**LIBERTY STREET SW DRAINAGE IMPROVEMENTS**  
**RFQ NO. 100313-FY18-46**  
**ADDENDUM #1**  
**JUNE 18, 2018**

### Trench Detail

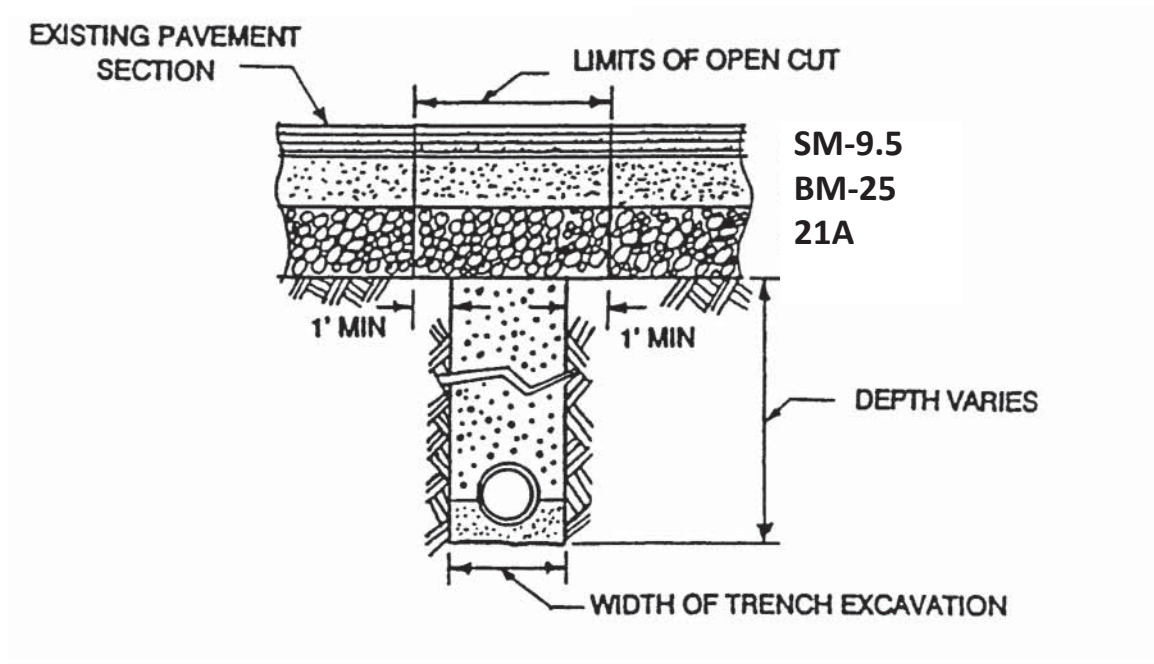
**Question 3:** Please Provide a Detail for the Trench Profile Requirements (Is there a cut back for the stone/asphalt).

**Answer 3:** **Trench detail is attached.**

- A. The Contractor shall replace the open cut with a minimum 1 1/2" VDOT Surface course SM-9.5, 3" VDOT Base Course BM-25.0 and 6" VDOT 21-A.
- B. All storm drainage installed shall be backfilled utilizing 21-A material, from the top of the bedding material used for the pipe to the sub-grade elevation.

DRAWING  
TS-13

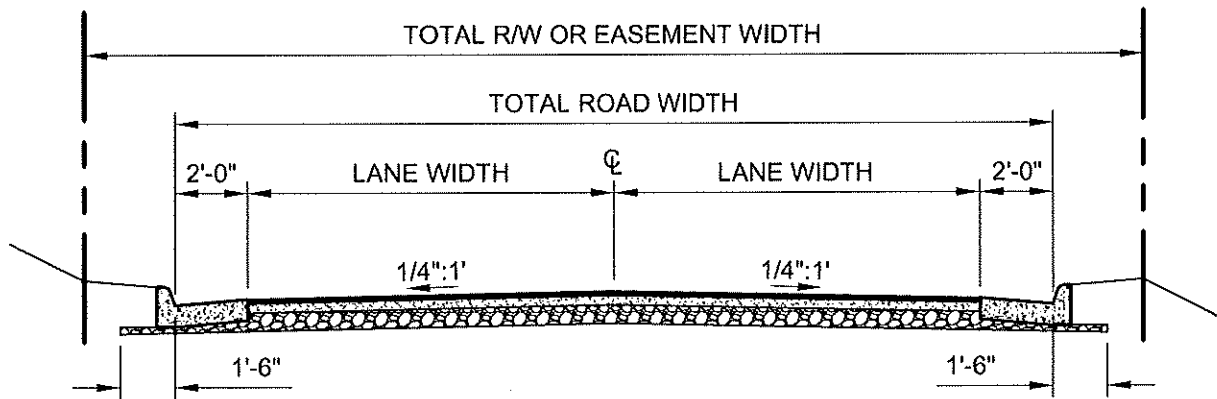
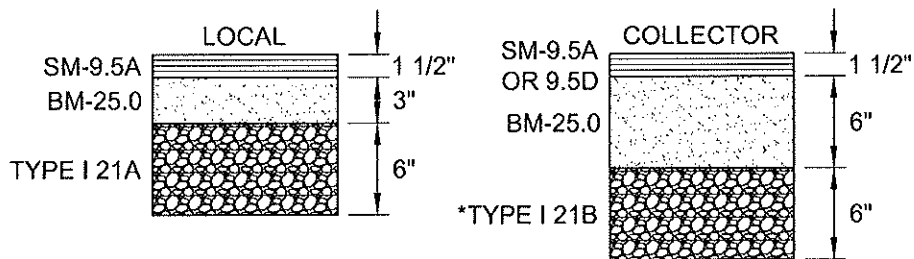
**Question 4:** What is the Base Asphalt Thickness Required for the Permanent Patch?

**Answer 4:** **The pavement section for the patch will be in accordance with the “Local” street typical section included on Drawing TS-13 – Typical Street Section of the Town of Leesburg Design and Construction Standards Manual, which requires 3” Base Asphalt thickness (copy attached).**
